3442 Gunston Road – Retaining Wall/Patio Hearing Resolution Worksheet

Date: December 18, 2019

Appeal to Board of Covenants Approval Denial for 3442 Gunston Rd

DIAGRAM BLDG. 729 72906 3442 GUNSTON

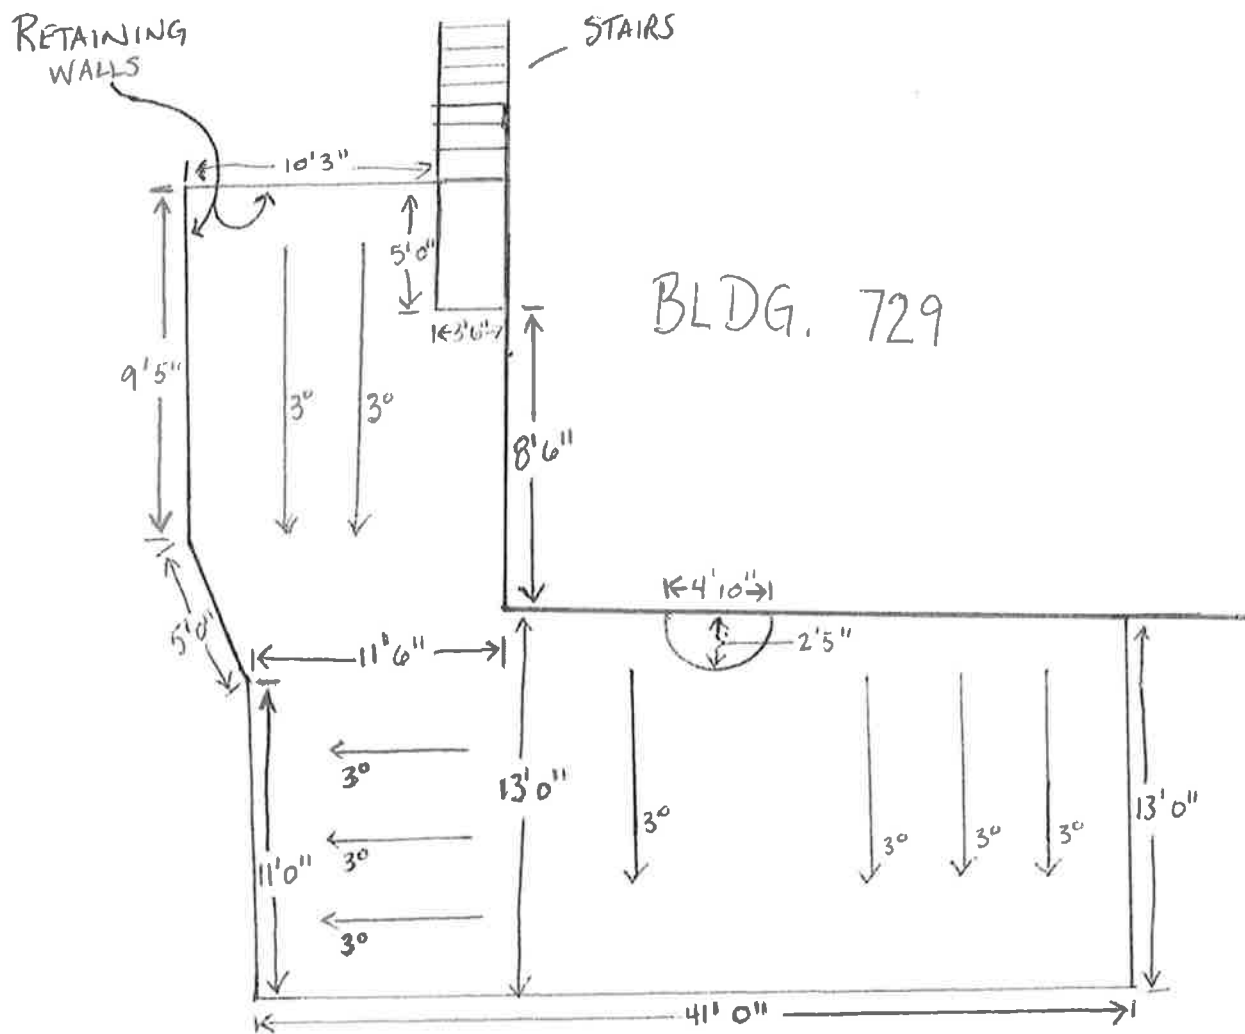
Stipulations/Reason for Denial: Patio/retaining wall does not comply
with current patio specifications. Patio extends
beyond the length of the building
